GOVERNMENT OF INDIA
MINISTRY OF ENVIRONMENT & FORESTS
Central Zoo Authority

F. No. 19-27/92-CZA(73)(Vol. V)(M) 2980

Sub:- Designs for the construction of various enclosures at Sayaji Baag Zoo, Vadodara (relocation of Ajwa Zoological Park at Ajwa).

The designs for the construction of various enclosures at Sayaji Baag Zoo, Vadodara (relocation of Ajwa Zoological Park at Ajwa) were placed before the Meeting of the Expert Group on Zoo Designing of the Central Zoo Authority held on 28th May, 2013.

ENCLOSURE FOR CROCODILE

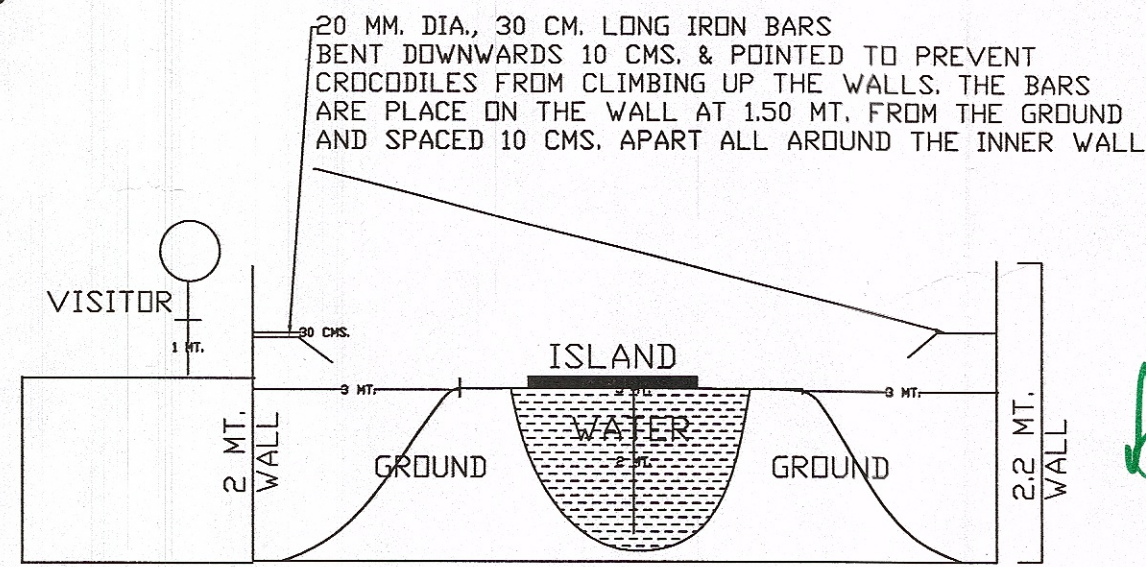
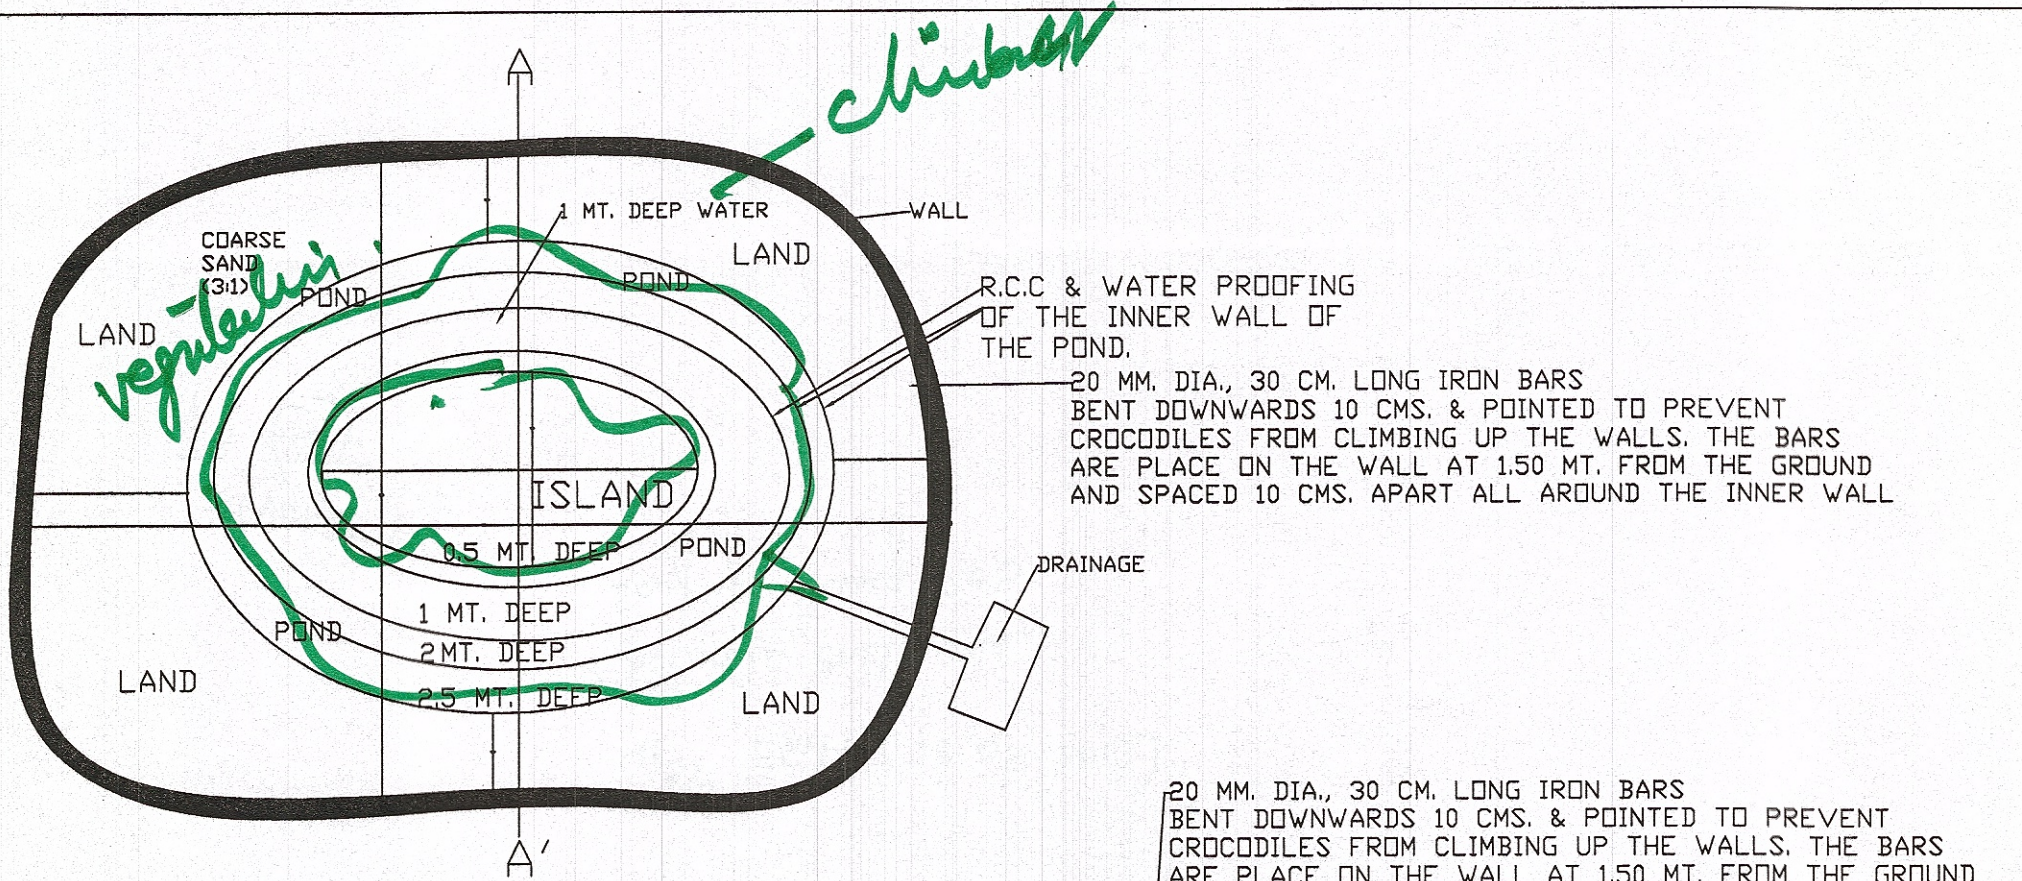
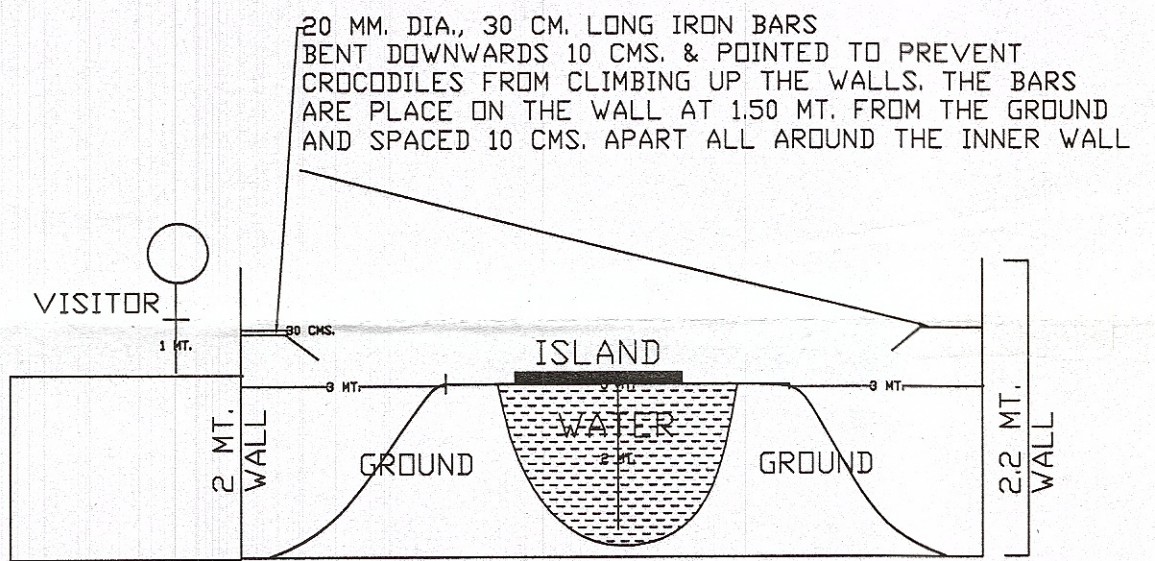
The design was scrutinized and approved subject to following:-

- (a) The outer wall of exhibit should be camouflaged by climbers and other vegetation.
- (b) The exhibit should have appropriate enrichment.
- (c) The shapes of the pond and water body should be irregular.

1 climber, etc
 2 vegetation
 enclosure
 Irregular shape
 A Pond/land
